PLANNING AND ZONING BOARD STAFF REPORT

398 NE 6th Avenue Development

Meeting	File No.	Application Type
February 23, 2026	2025-082-SPF-LV3	Level 4 Site Plan with waiver
Property Owner	Applicant	Authorized Agent
Delray 6 th Avenue Realty, LLC, Salvatore Ditta	Same as Owner	Bradley Miller

REAR ELEVATIONS

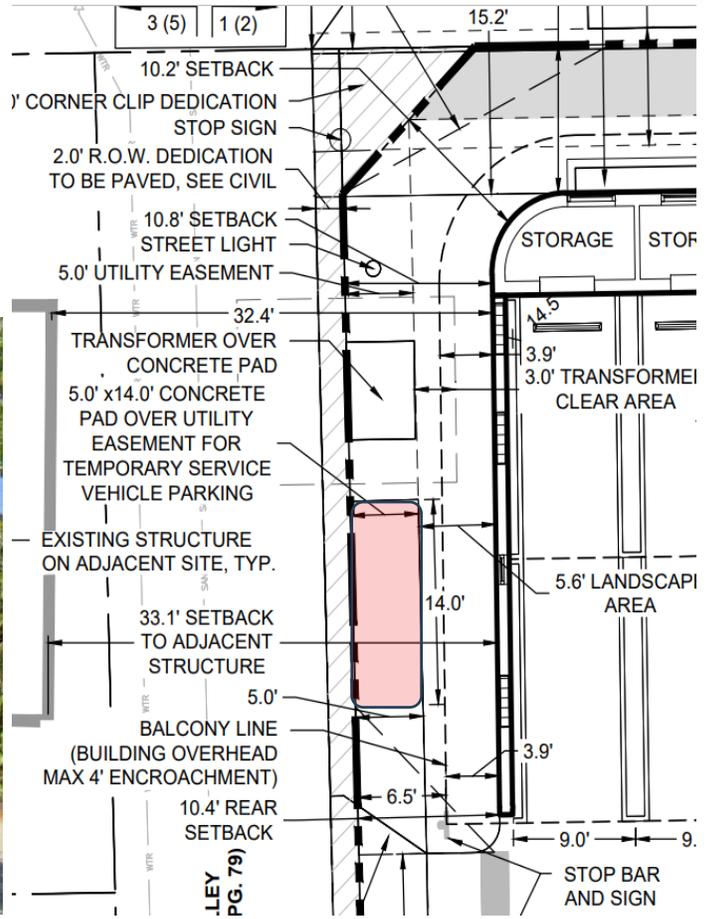
While this development proposal does not include any on-site dedicated loading zone, in-lieu of a full-sized loading berth, the applicant is proposing a 5-foot by 14-foot concrete pad located adjacent to the alley, within the site, to accommodate delivery vehicle pull-off and short duration loading activities. While this does not meet the dimensional standards of the LDR, it represents a deliberate attempt to address loading needs in a constrained urban setting. As such, it can be expected that during periods of move-in/move-out and delivery of large furniture and appliances, vehicles will at least partially obstruct the alley for significant periods of time. This may negatively impact the open flow of the alley network and negatively affect surrounding properties. The alley currently functions as a

shared service corridor for multiple properties. Surrounding developments, including the property at 393 NE 5th Avenue and adjacent parcels to the south, already utilize the alley for parking, circulation and service access. The proposed project follows this established pattern by orienting parking, refuse, and delivery activity toward the alley rather than primary streets.

Given the modest scale of the development, the frequency of loading is expected to be limited and primarily associated with residential move-ins, package deliveries, and small-scale retail operations.

As such, the proposed arrangement is not anticipated to create a significant or unsafe impact on the alley or surrounding street network. Instead, it represents a practical response to site constraints while maintaining the intent of the loading and circulation standards by keeping service away from major street networks. In evaluating the proposed loading arrangement, the Board should consider whether the alternative approach adequately fulfills the intent of Section 4.6.10 of the Land Development Regulations, which is to ensure that loading and service activities occur in a manner that protects public safety and maintains efficient circulation. The applicant's justification is attached.

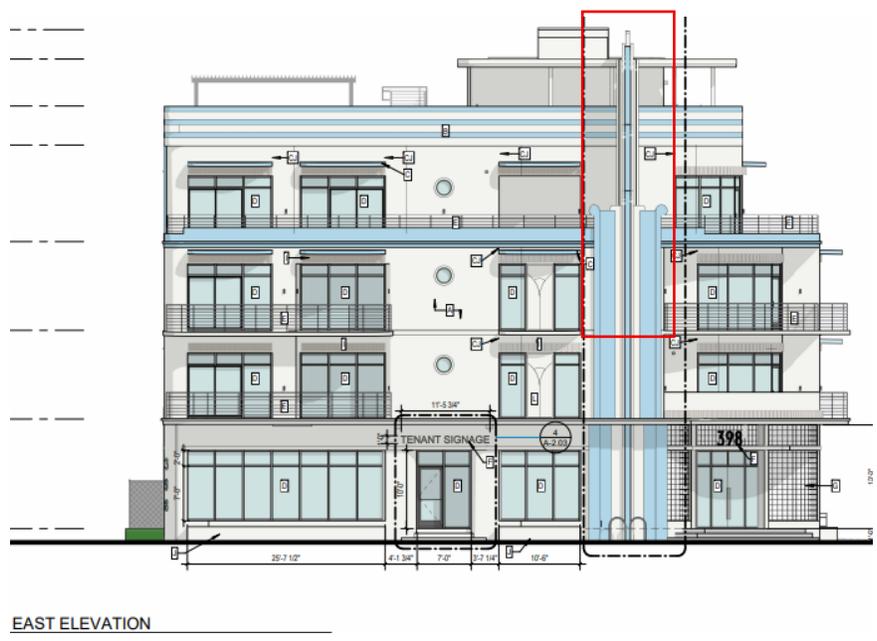
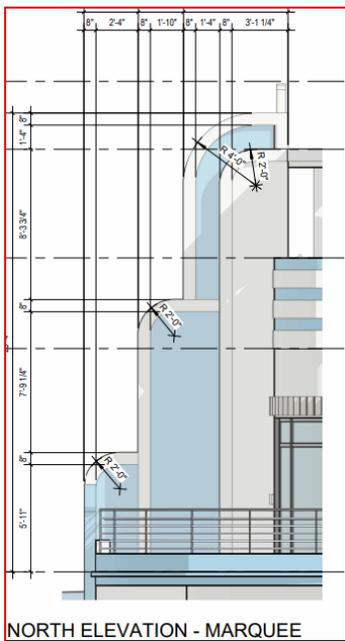
The proposed design incorporates a tower element extending above the third story, providing vertical articulation and reinforcing the building’s corner presence. LDR Section 4.4.13(D)(2)(a)1.b. provides that, with approval from the board, building entries, lobbies, and vertical circulation areas located above the second story may not be required to increase the setback to 20 feet when configured as tower elements determined to be consistent with the CBD Architectural Design Guidelines.

The tower element appears integrated into the overall Art Deco architectural composition through consistent material application, horizontal banding transitions, vertical emphasis, and proportional relationship to the primary building mass. Vertical tower or marquee-style elements are characteristic of Art Deco architecture, where vertical features are often used to contrast strong horizontal banding, emphasize building entries, and create visual identity at prominent corners. The proposed tower element reflects these architectural principles and is incorporated into the overall façade composition rather than appearing as an isolated vertical projection.

From an architectural and urban design perspective, this element contributes to façade articulation, corner identity, and skyline variation typical of mixed-use buildings within the Central Core Sub-district. The Board may determine that the tower element is appropriate, consistent with the Architectural Design Guidelines, and may approve the configuration as presented.

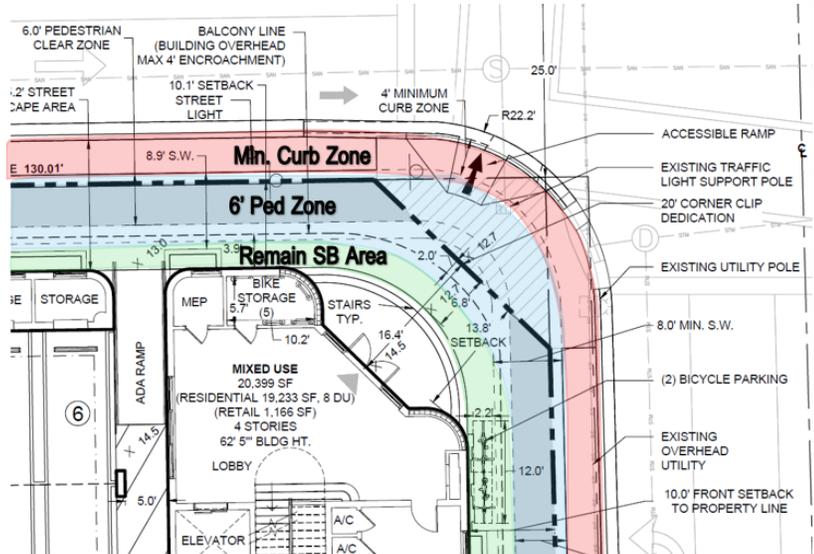
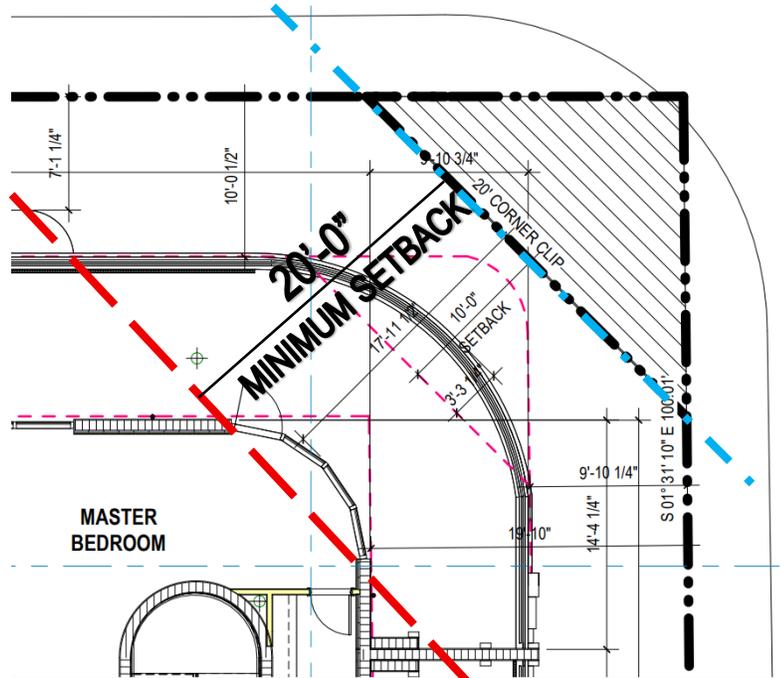
The subject property is on a corner lot, subject to LDR 4.4.13(D)(2)(a), which mandates that any portion of a structure above the third story maintain a minimum front and rear setback of 20 feet, measured from the property line. Additionally, a 20-foot by 20-foot corner clip is required at the intersection, resulting in a newly established, clipped property line.

The applicant is requesting a waiver to reduce the required 20-foot front setback above third story to 17 feet, 11 inches. The need for the waiver arises from the required corner clip, which shifts the point of measurement inward at the intersection. While the building generally complies with the 20-foot setback when measured from the original lines, the clipped corner condition creates a localized encroachment of approximately 2 feet and 1 inch above the third story.

Architecturally, the building incorporates an Art Deco design characterized by a prominent rounded corner element that accentuates the intersection and establishes a strong visual anchor. This curved feature is intentionally designed to address the corner condition, enhance pedestrian orientation, and create a defined architectural entry statement. The reduced setback occurs specifically at this rounded corner element above the third story, where strict adherence to the 20-foot setback from the newly clipped property line would compromise the continuity and integrity of the architectural expression.

Given that the deviation is minimal in scale and directly attributable to the mandatory corner clip, the request can be viewed as a technical adjustment rather than a substantive intensification of massing. The overall building depth above the third story remains consistent with the intent of LDR Section 4.4.13(D), and the articulated corner design continues to promote high-quality architecture and an activated streetscape consistent with the design vision for this area of the City.

Furthermore, the requested waiver does not interrupt or diminish the required streetscape design because the encroachment occurs only above the third story. At the pedestrian level, the building fully complies with the minimum 10-foot front setback, and a streetscape design of at least 15 feet is maintained in accordance with LDR Section 4.4.13(E)(2). As a result, the ground-floor relationship to the public realm, including sidewalk width, landscaping is consistent with code requirements.
